Historic Preservation Board

5:30 PM – Wednesday, March 08, 2023 – City Hall

[4.1](#) Certificate of Appropriateness 2023-COA-01 for Construction of A New Fence at 524 E Lemon Ave

[4.2](#) Certificate of Appropriateness 2023-COA-06 for Shed Installation at 403 S Mary St

EXHIBIT B: ELEVATIONS OF PREVIOUSLY PROPOSED SHED

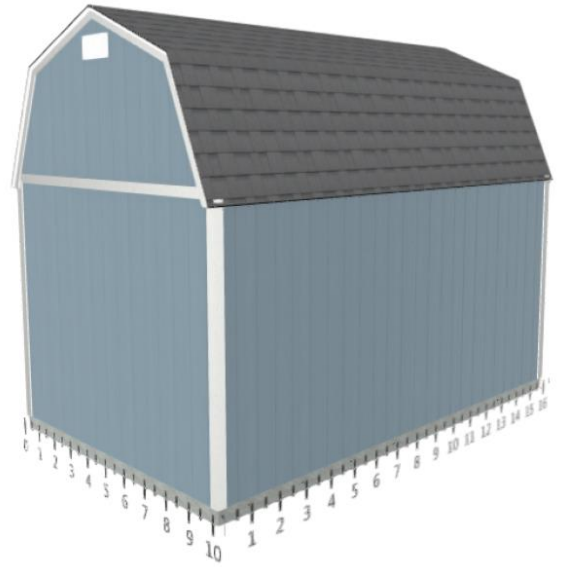
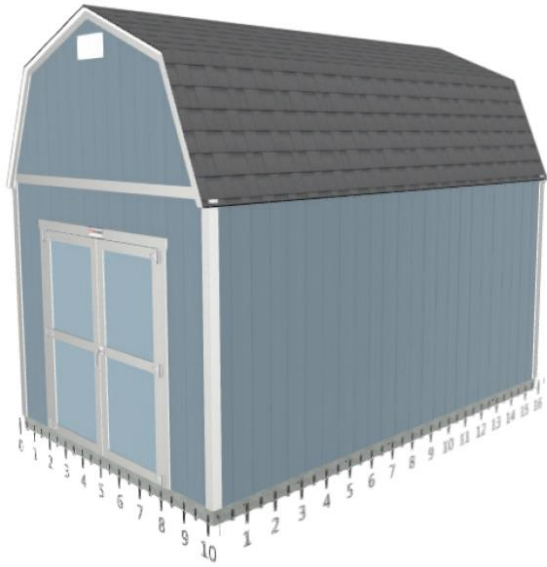
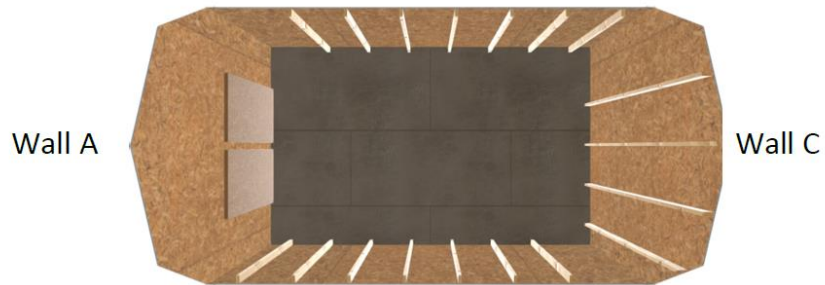
Ms. Croney then explained the criteria to be used in evaluating the request. She stated the roof pitch of the proposed shed is not consistent with the frame vernacular style. She indicated it would need to match the color of the existing home. She cites ways the shed could be altered to be more compatible with the home. She reviewed the timeframe for the project including issuance of the building permit. She stated the proposal does not have any significant inconsistencies and commented on changes they were making to make it more consistent. She stated no landscaping plan was provided or needed for the application. She indicated that if they could provide a shed with a roof that more closely matches the existing home that would be preferable. She stated that staff is recommending denial with a suggestion that the applicant propose a shed more compatible.

No windows are proposed to be as part of the shed, but the addition of windows, or even faux windows, would increase the suitability and agreeability with the frame vernacular architectural style. New windows could potentially be only added on the façade that faces the road and is visible to the public. In this style, double-hung sash windows are generally made of wood and spaced evenly along all facades. Windows can be single-pane, or 2- or 4-pane.

EXHIBIT C: ELEVATIONS OF NEW REVISED PROPOSED SHED

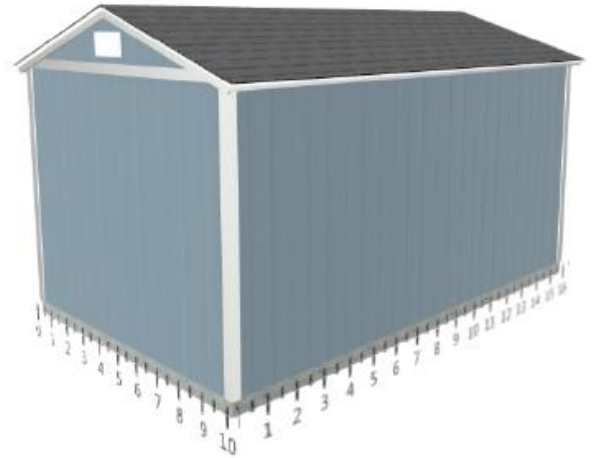
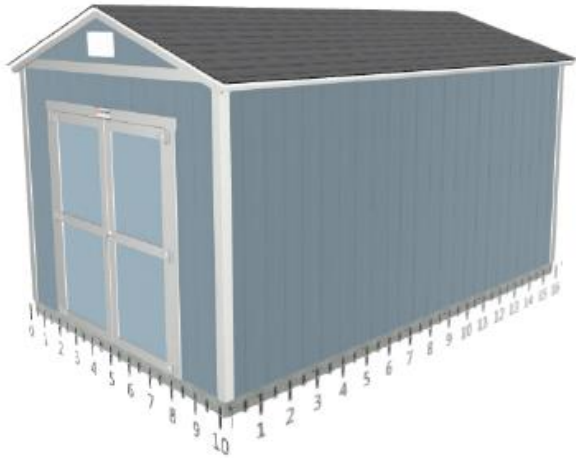
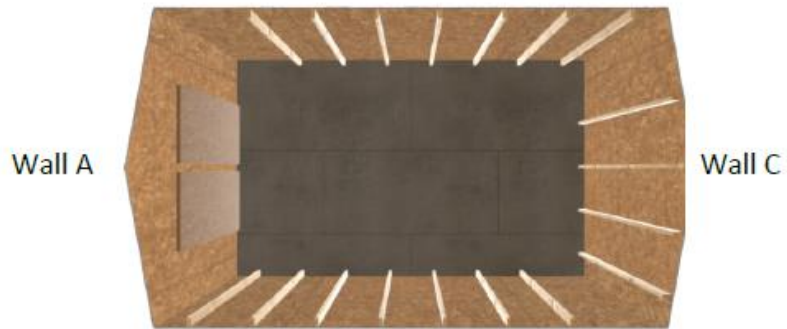
The pitch and style of the roof of the new, revised shed that is now proposed more closely match that of the existing single-family residence on the property.

Based on the analysis above, the criteria for evaluation provided in this memorandum, the revised shed is now more consistent with the subject property's historic frame vernacular style and existing development, but there are still areas for improvement and a greater consistency, such as in regards to windows and color. During the last Historic Preservation Board meeting, during discussion of this request, members of the public stated that there is a fence on the property that should block most of the view of the shed from the public, and there is a fence permit approval on record from 2009 for 6-foot tall white vinyl fence on this property. Especially if there is (and is to remain) a fence on the property that would hide or disguise the shed and any lack of consistency with the historic site, staff would recommend approval of this request. The Board may choose to, if they would like, require that a fence remain to hide the shed from the public view.
